**PLANNING COMMISSION
MEMORANDUM**

AGENDA ITEM: Planning File No. MAJ-25-0002: A sketch plan review of a proposed mixed-use development consisting of five (5) new residential units in addition to keeping existing uses on site

LOCATION: 121 E Main Street / Sixth Degree Town Homes

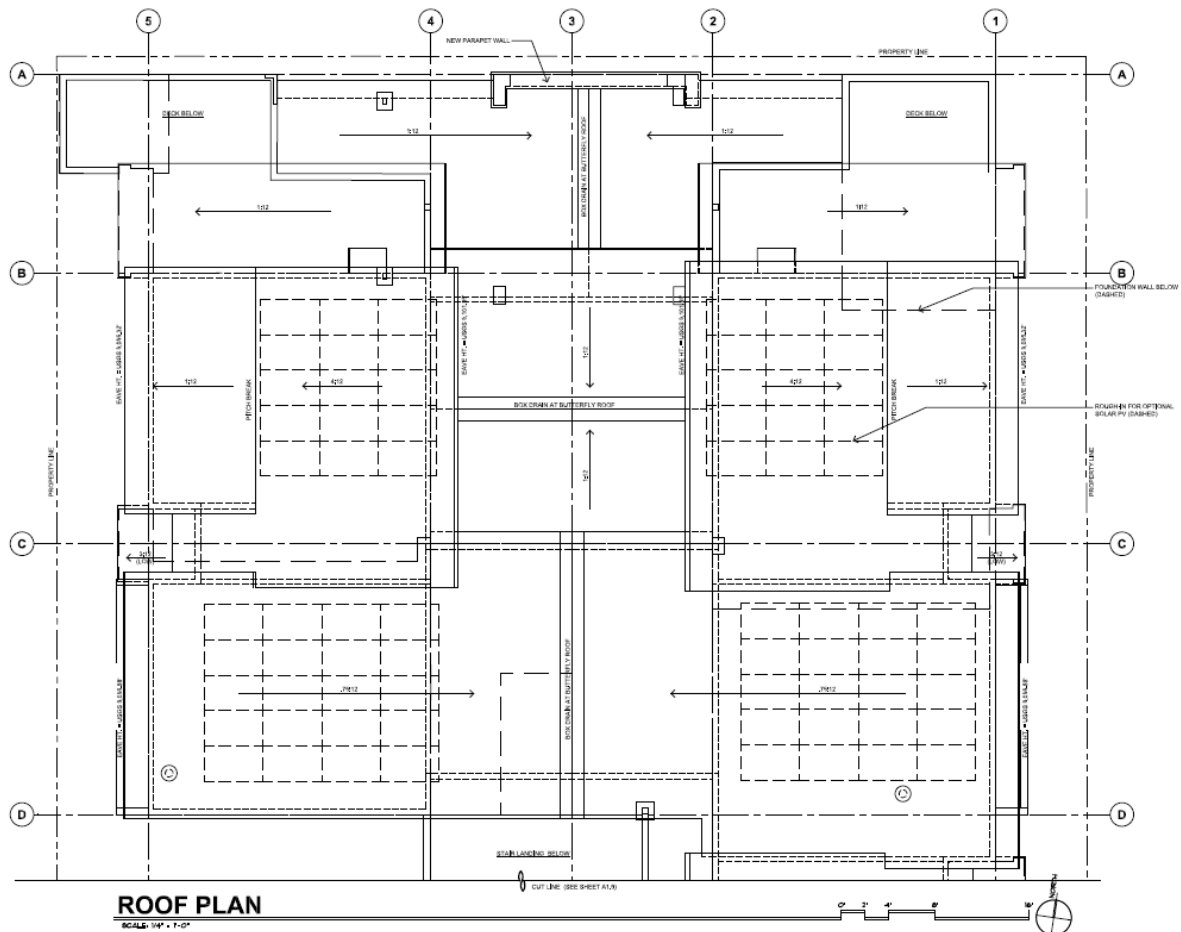
The Application shows a combination of pitched and flat roof designs with parapets, including roofs that face the street. Staff requests that the Planning Commission provide feedback to the Applicant on the proposed roof pitches.
